5.12 DESIGN EVOLUTION :

This section documents a study undertaken as a response to a request from Camden to investigate the setting back of both the north and south glazing line of the R01 unit by 500mm:

**5.14 DESIGN EVOLUTION - OPTION 01:
500MM SETBACK TO BOTH NORTH & SOUTH FACADES
PLAN**

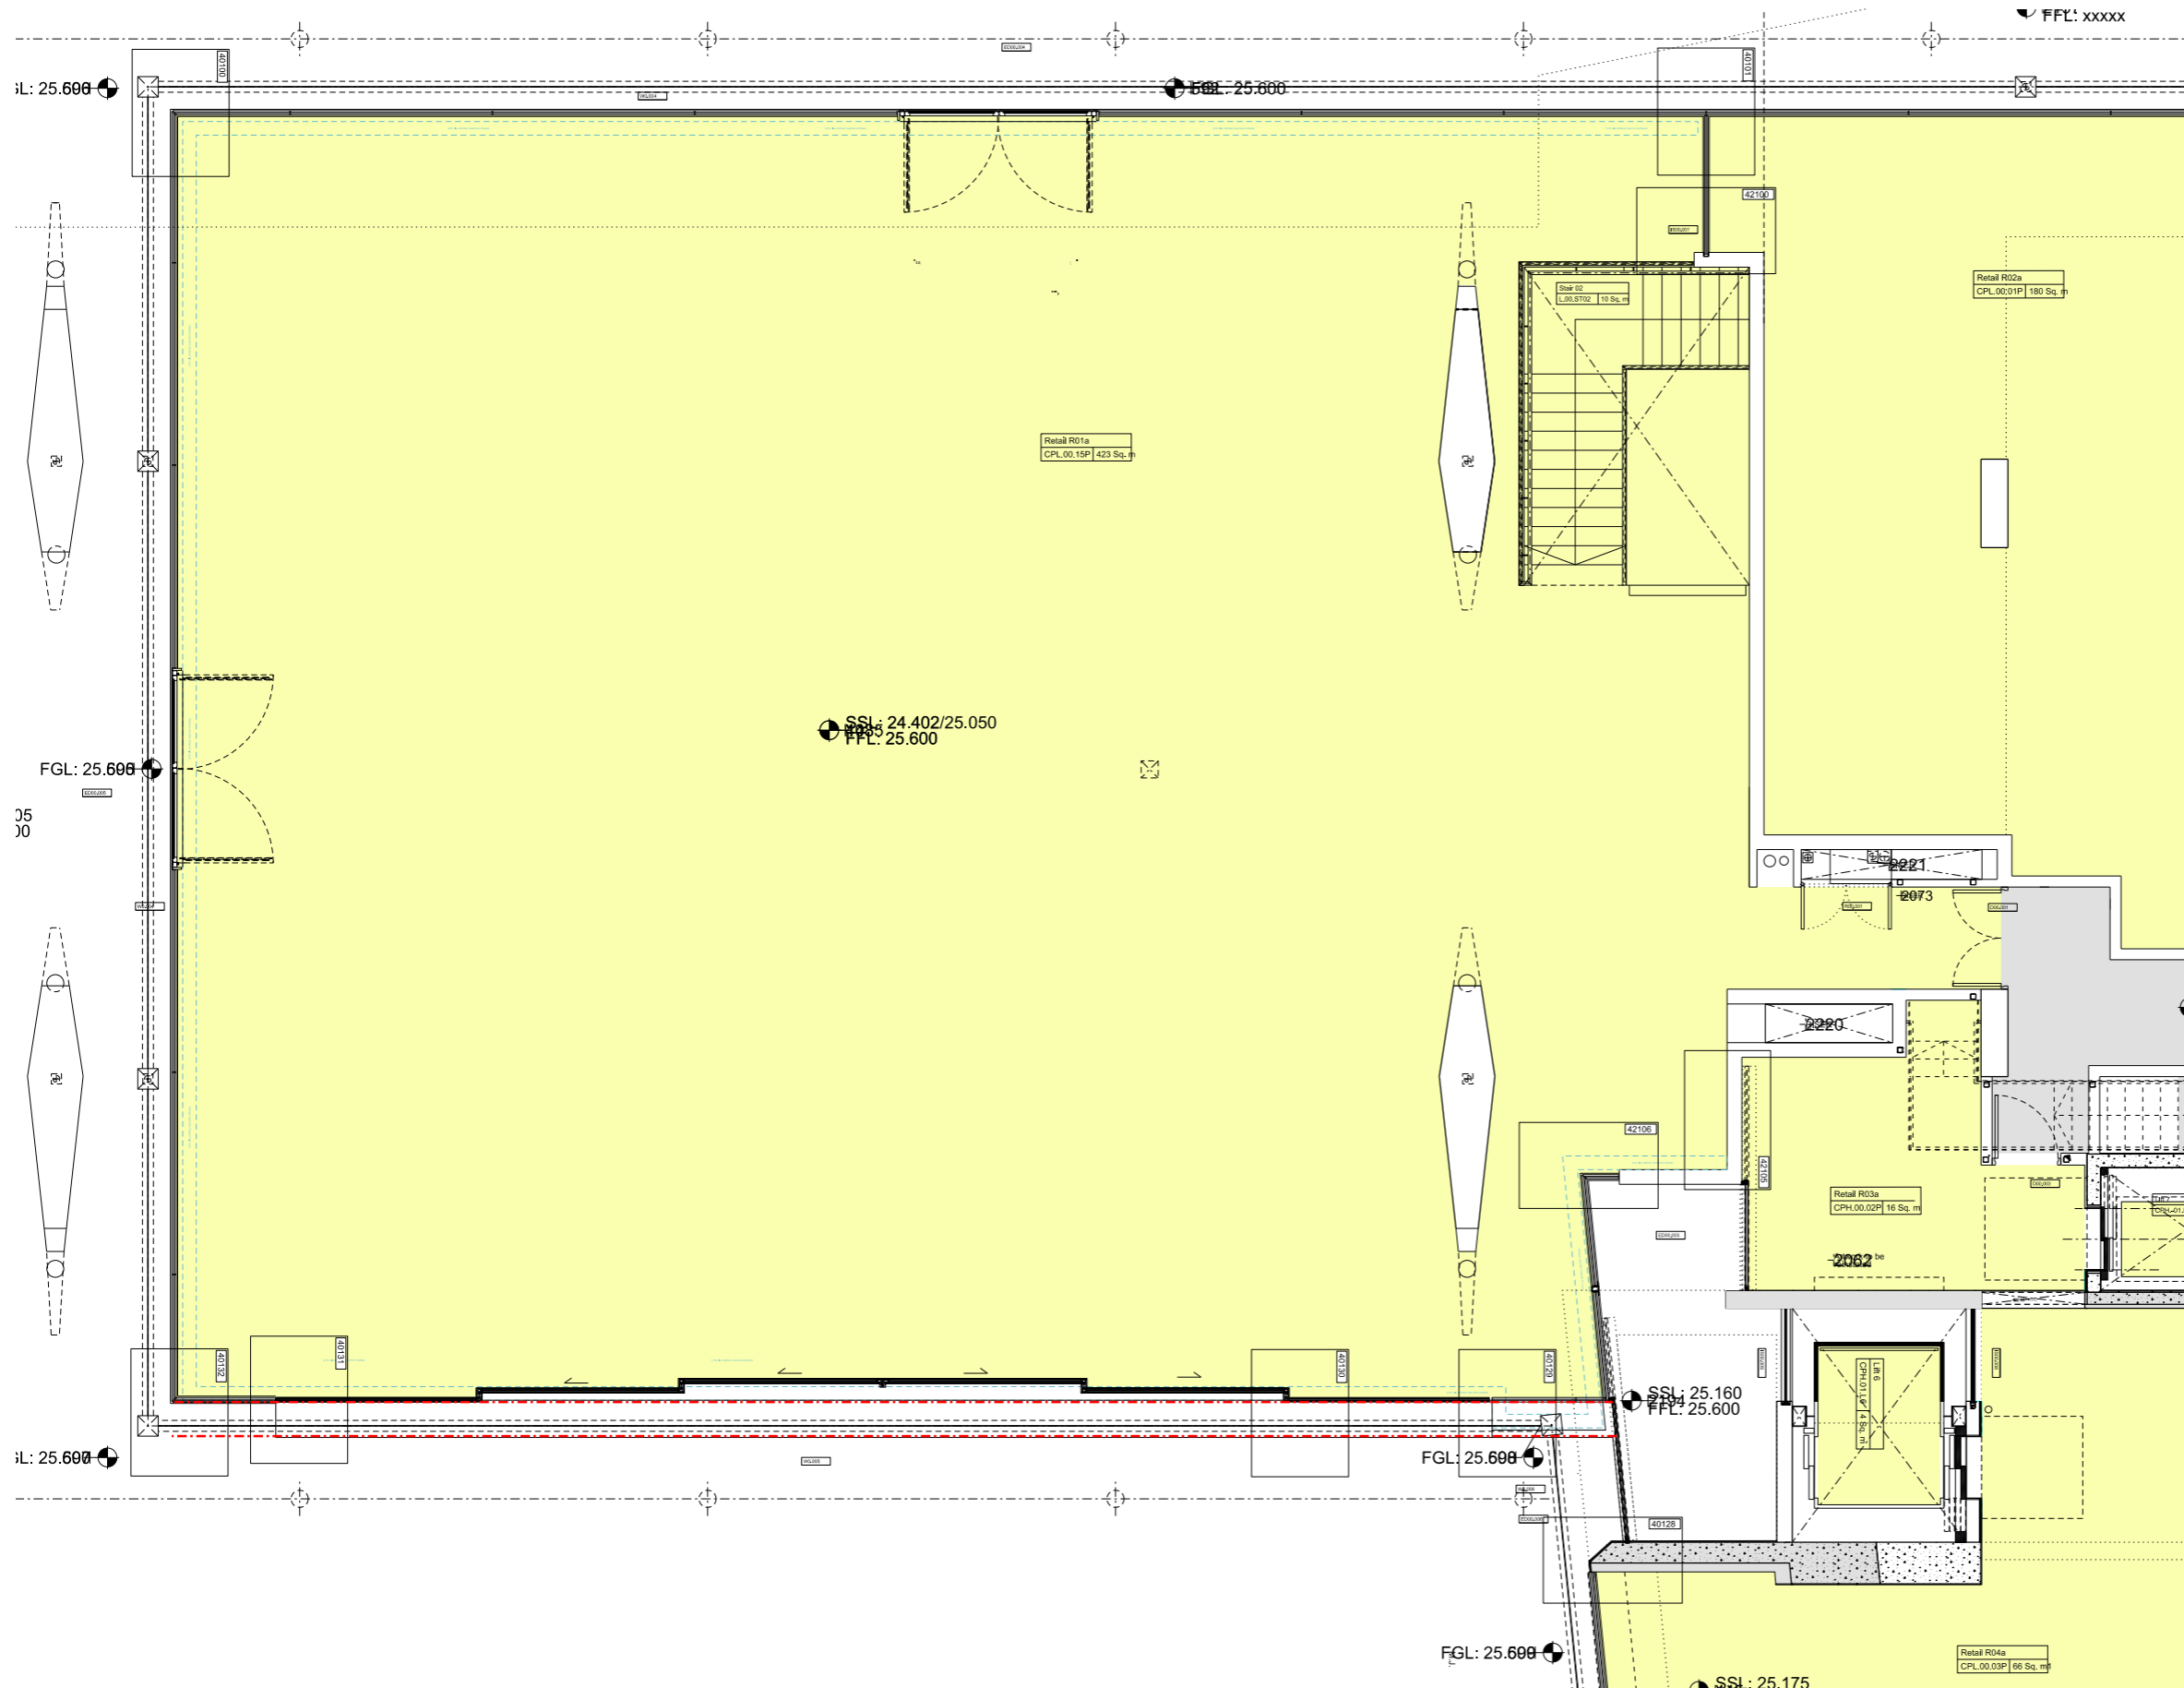
Option 1:

500mm setback to both North & South Glazed facades.

- Reduction in R01 area from street and square

- Compositional/visual complication due to extra junction to north facade. Caused by resultant misalignment with R02 facade (consented).
